Planning Staff Analysis

**Z-101**

Date: **January 30, 2017**

**REVISED SUBJECT TO SITE PLAN RECEIVED JAN. 25, 2017**

Z-101  
(2016)

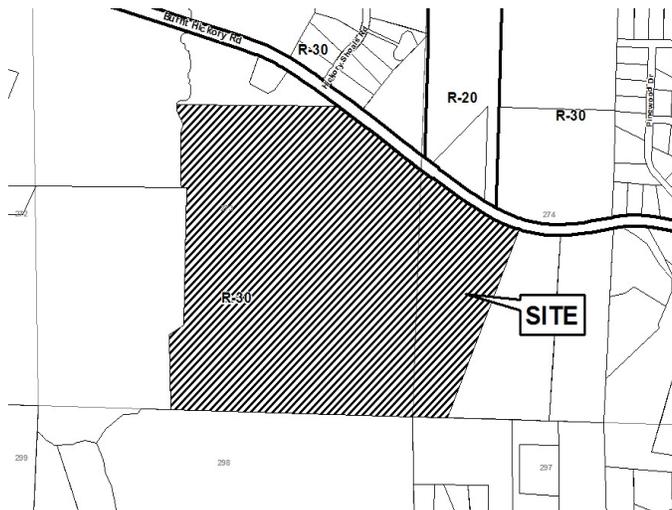
1. Provide acreage of floodplain and wetlands on site plan.
2. Area of "Possible Water Quality Pond" in the south eastern portion of the tract must be omitted from open space calculations.
3. If walking or bike trails are proposed throughout open space please add them to site plan and note that they must be constructed of porous materials.
4. Must have Cobb Department of Transportation approved lighting plan in if outdoor lighting (except individual residential lots) is proposed

5. A Conservation Easement must be recorded in the mandatory subdivision covenants and with Cobb Superior Court, thereby protecting the “Open Space” from development in perpetuity as owned by the mandatory Home Owners Association. Conservation Easement application must be submitted to the Planning Division before final plat approval.

6. For all lots contiguous to open space staff recommends including a deed during sale of homes so that future lot owners are aware that commonly owned open space exists adjacent to their property and cannot be built on. Or, as another form of privacy barrier staff recommends installing fence (split rail or any fencing compatible with architecture/landscaping/design of development) to the rear of lots that are adjacent to open space.
